Opuha Dam
Annual Dam Safety Inspection 2013

Report prepared by:
Tonkin & Taylor Ltd

April 2013

T&T Ref: 51134.004

Figure 7 Drain D18 flows, pre and post grouting Piezometers

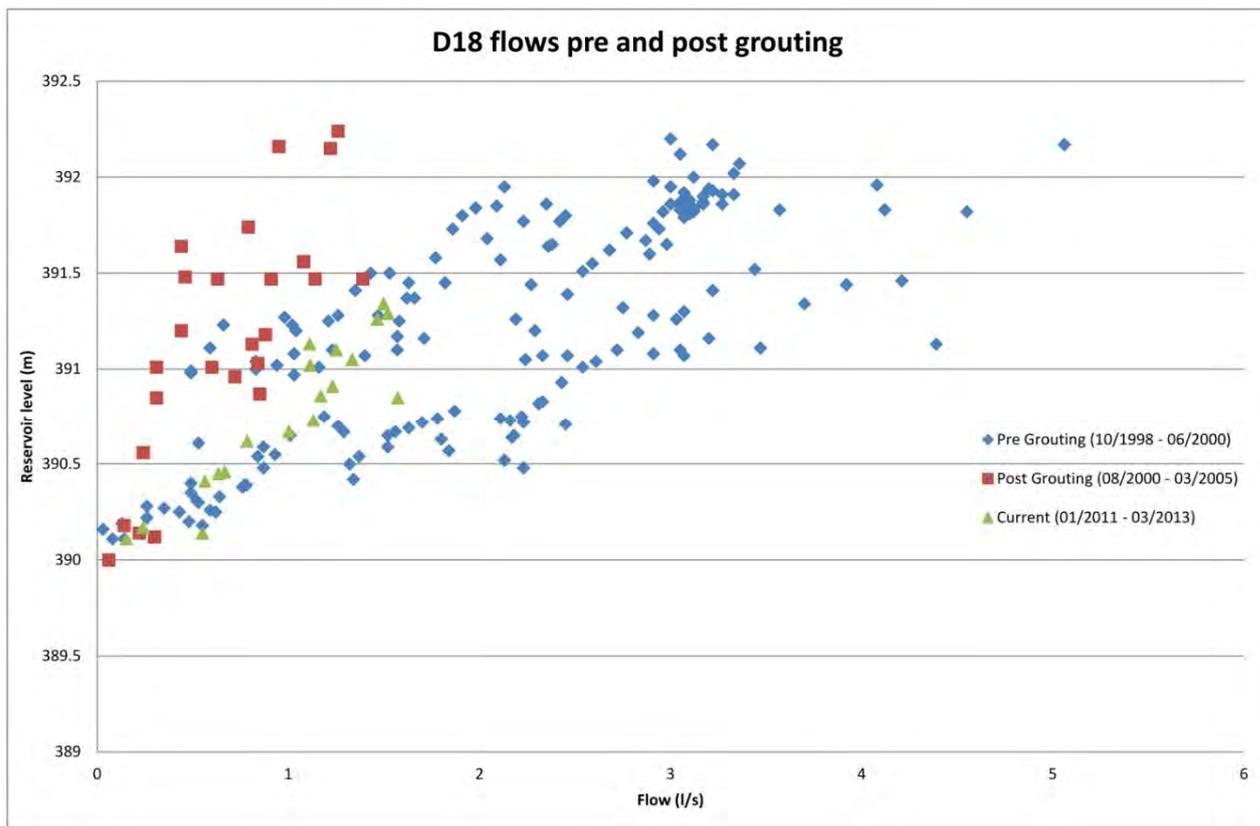
Grouting of the upstream three meters of D18 was carried out in July 2000 as a result of the April 2000 Six Monthly Inspection recommendation. Figure 7 below shows the flow produced pre-grouting, post-grouting and current flows from the drain. From the plot it can be seen that at equivalent reservoir levels, flow has increased from post-grouting to current flows produced.

Given the long term trend of increasing flow from this drain, we recommend that an investigation is completed to identify the source of the seepage, and a concept developed for works to reduce this seepage. This is outlined in Section 7.3.

Figure 26 Release valve

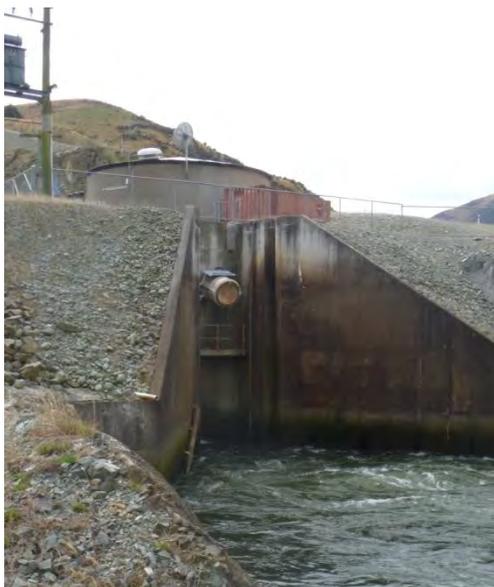
The seismograph that OWL currently possesses is not operational. Resource Consent CRC950579.3 requires the consent holder to devise and carry out a monitoring programme which measures and reports on the seismic accelerations at the dam. It is recommended that a seismograph is set up in the powerhouse to allow for a more accurate reading of any future seismic movement at the dam location.

Figure 33 Undermining of chute

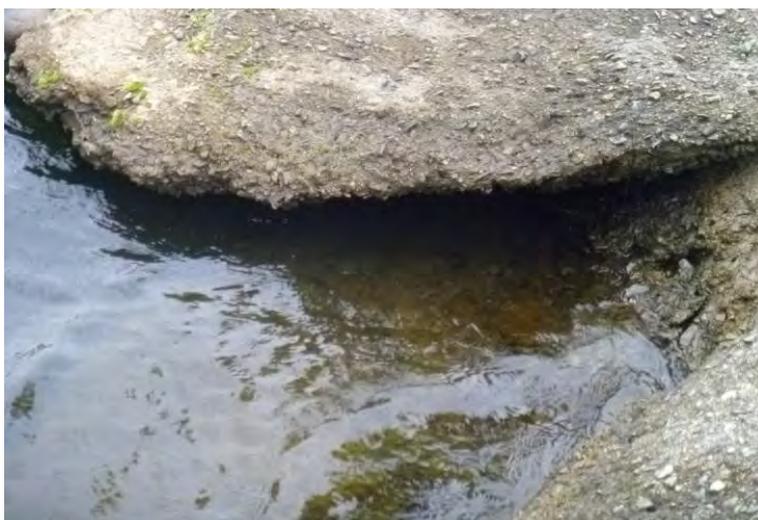
The concrete and stone armouring on both banks is generally in satisfactory condition. It was previously noted that the mass concrete beyond the end of the chute right hand training wall (beyond the toe of the ogee weir) is at least partially undermined. This remains unchanged since the previous period but ongoing monitoring of this area by OWL is warranted.
